Access Compliance Report

Public Rights-of-Way

(Pedestrian Signals)

Intersection ID: N/A	Main Street:	Cross Street: N/A	Location: N/A
ADA ID: 733D35F9098A	Signal Type: One Push Button-Non APS	Overall Compliance: No	Severity Score: BTN 1: N/A BTN 2: N/A No BTN: N/A
Codes/Mitigation Info/Possible Solution		Field Measurements/Component Compliance

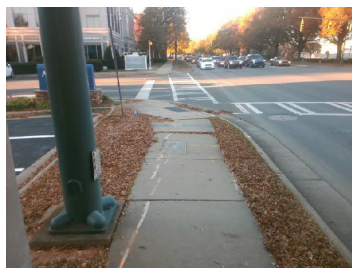
PROW/ADA: TMUTCD 4e.08, R404.2, R404.3, R404.7.3

Possible Solutions: Replace Signal Push Button With APS Button on New Post. Remove & Relocate Sign.
